R44

SERVICE BULLETIN SB-13

SUBJECT: Collective Spring Assembly and Spring Assembly Support Replacement

FIGURE 1

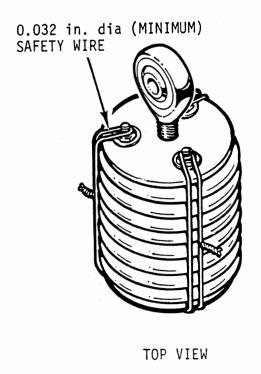
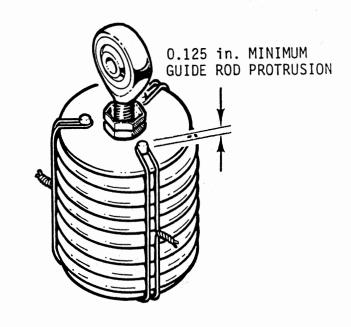
BACKGROUND: RHC has received reports of guide rods in the collective spring assembly becoming bent or broken, resulting in stiffness in the collective control. RHC has redesigned the assembly with stronger guide rods. In addition, the collective spring assembly upper support was redesigned to improve the effectiveness of the spring.

Place collective in full down position. If MT544-1 tool is available, place tool over collective spring with upper and lower rod ends resting in V-notch of tool. If MT544-1 tool is not available, rotate spring as necessary until spring guide rods extend from lower spring assembly cap a minimum of 0.125 inch. Wrap 0.032 inch diameter minimum safety wire from nut end of guide rod to opposite bare end of guide rod as shown in Figure 1. Wire all three rods as shown.

Place collective in full down position. If MT544-3 tool is available, place tool over collective spring with upper and lower rod ends resting in V-notch of tool. If MT544-3 tool is not available, rotate spring as necessary until spring guide rods extend from lower spring assembly cap a minimum of 0.125 inch. Wrap 0.032 inch diameter minimum safety wire from nut end of guide rod to opposite bare end of guide rod as shown in Figure 1. Wire all three rods as shown.
